UNITED STATES PATENT AND TRADEMARK OFFICE

10/817,666

Office Action Summary	Application No. 10/817,666	Applicant(s) PIELMEIER, GUNTER	
	Examiner JESSIE FONSECA	Art Unit 3633

DETAILED ACTION

Fig. 2: Hulsekopf (US 4,407,100)

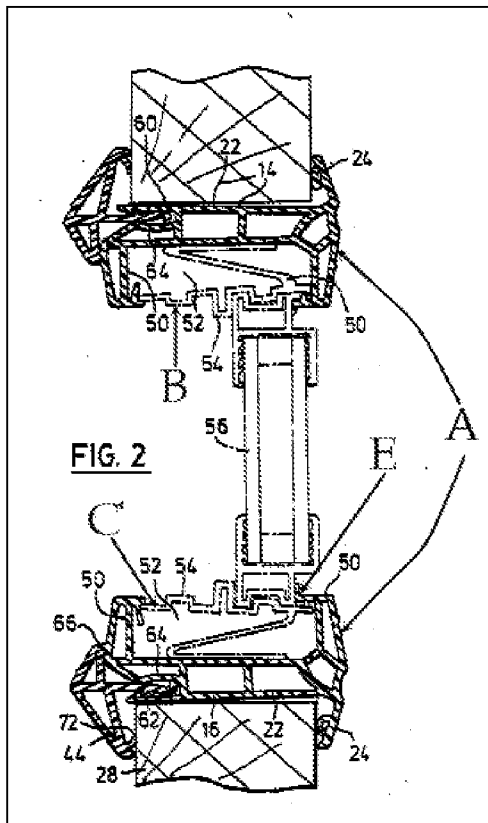
With regards to claim 1-3: Huelsekopf discloses a container (28) having a wraparound installation frame (10) connected to a window frame (A), wherein the interior side of the container (28) is equipped with a back square (12) that is connected to the installation frame (10) (figs. 1-3). The back square (12, figs. 1-3) of Huelsekopf would be considered to perform equally well to that of applicant's as it provide stability and alignment of the window to the container wall opening. Note the back square connected to installation frame is capable of being adjusted to the thickness of the container wall as the back square includes barbs (48) that may engage the installation frame at varying thicknesses.

Huellsekopf further discloses a "shutter frame" (B) received into the open upper frame portion of the wrap around installation frame (10), wherein the "shutter frame" (B) is interposed between the upper frame portion of the window frame (A) and installation frame (10) (fig. 3)

Huelsekopf further discloses cover (C) for placement in the grooves of the bottom and lateral frame portions of the installation frame (10), wherein the installation frame (10) is connected to the window frame (A) by means of a bracket (E) that is capable of snapping into the groove of the window frame (fig. 2). Note that any material has some

degree of elasticity as a force can be applied to the material, wherein that material can return to a state of equilibrium without sustaining permanent damage.
